Intel[®] Communications Chipset 89xx Series

Specification Update

Document Number: 328000-001US

Figure 2. 1000BASE-BX/FC-PI Transmitter Electrical Specifications

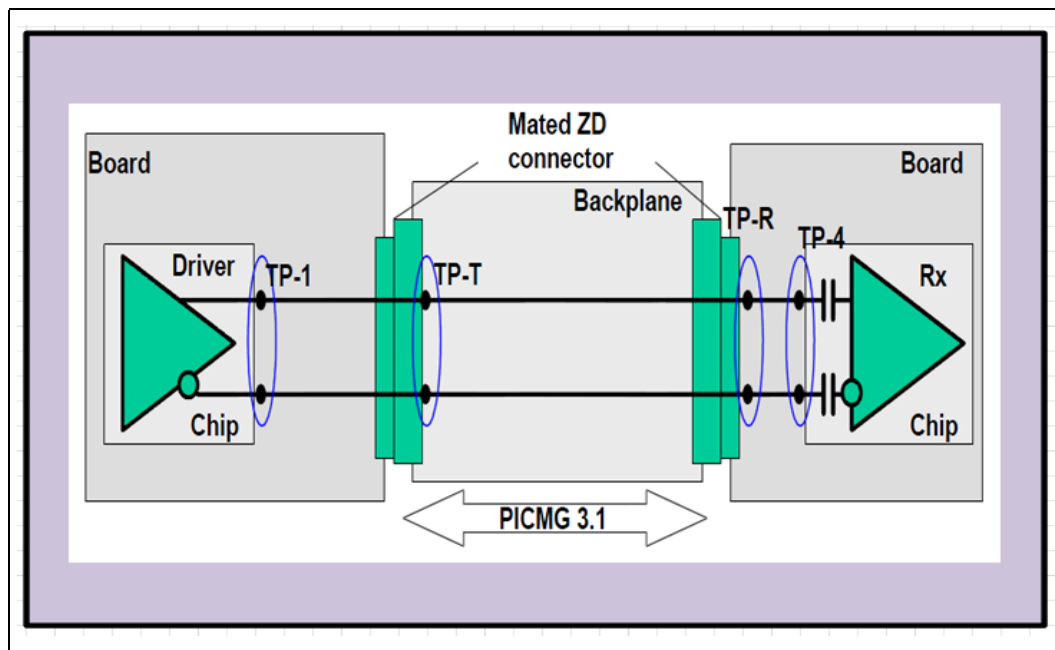
Implication: Although this is a specification violation, it does not affect the functional operation of the interface.

Workaround: Ensure that the signal routing length from TP-1 to TP-4 is greater than 10". Refer to Intel® Communications Chipset 89xx Series Platform Design Guide (PDG) for maximum routing length. (See Figure 2).
